Lapstone Playing Fields Enhancements (F/22/94174)

Ecology Consultation

Applicant Response

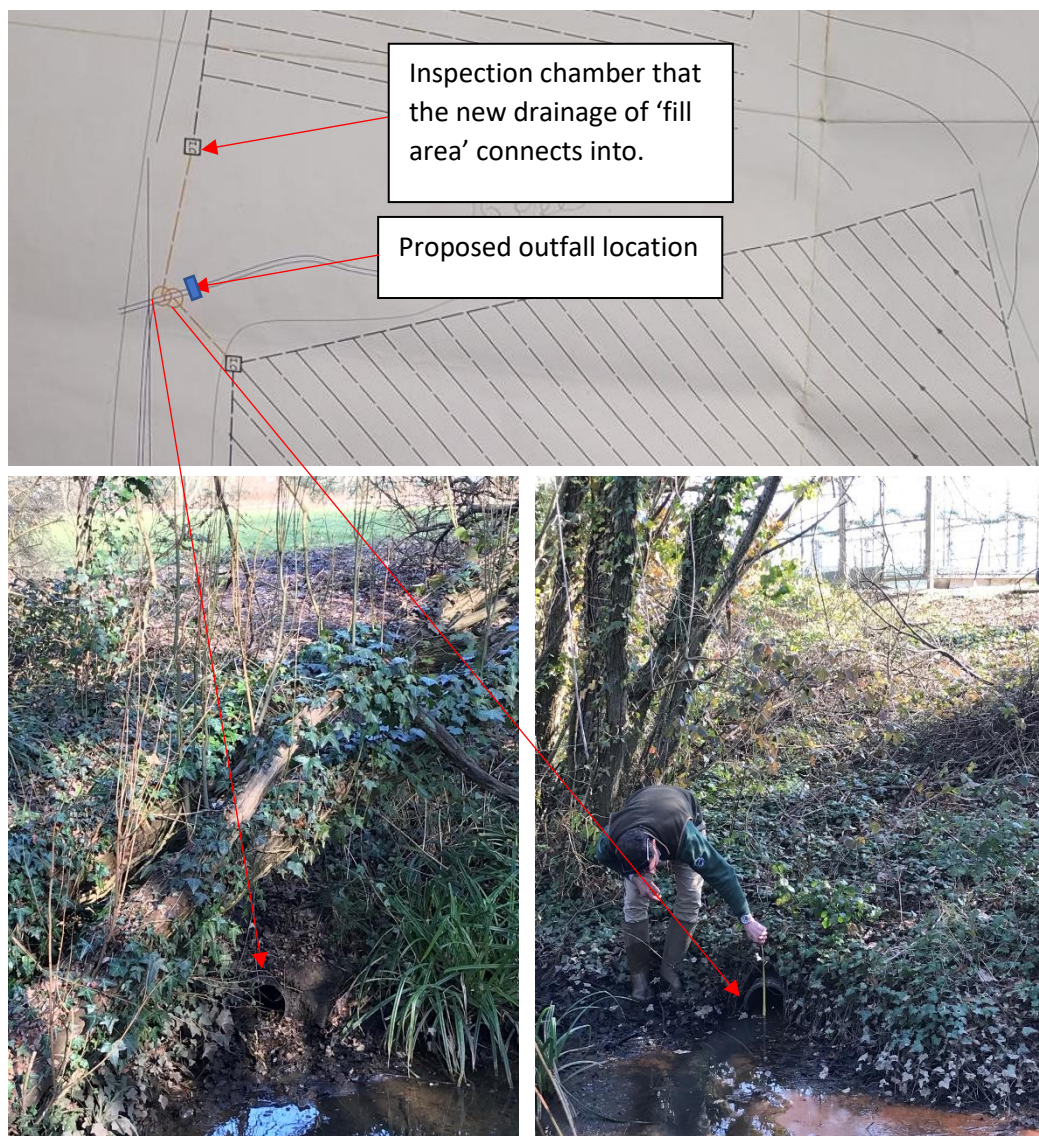
Consultee Comment: Plan *Existing Primary Drainage System_Lapstone* is referred to in the DAS but I cannot find this plan.

It is not clear on the proposed drainage plan where the water will be coming from to supply the wet woodland compensation area in the south-west of the site. It is understood that the drainage from the football pitch (and possibly other areas of the playing field) will be directed to this area. This needs to be shown and demonstrated that a sufficient amount of water will reach this wetland habitat.

Any excavation associated with the drainage and wetland creation will have to be away from existing trees and their RPAs. This will also protect the Wyvern Technology College Meadow SINC which is adjacent to the site at the southern half of the site's western boundary

Applicant Response: Please see attached existing drainage design for reference. The 'wetland area' will be created by connecting into the existing collector pipe that runs south to north and discharges

into existing drainage ditch. Whilst relatively flat, the topography of the site does also fall this way, meaning surface water will also naturally travel and collect in this direction.

The replacement 'wetland area' has deliberately been offset to ensure it avoids the RPA's of existing trees.
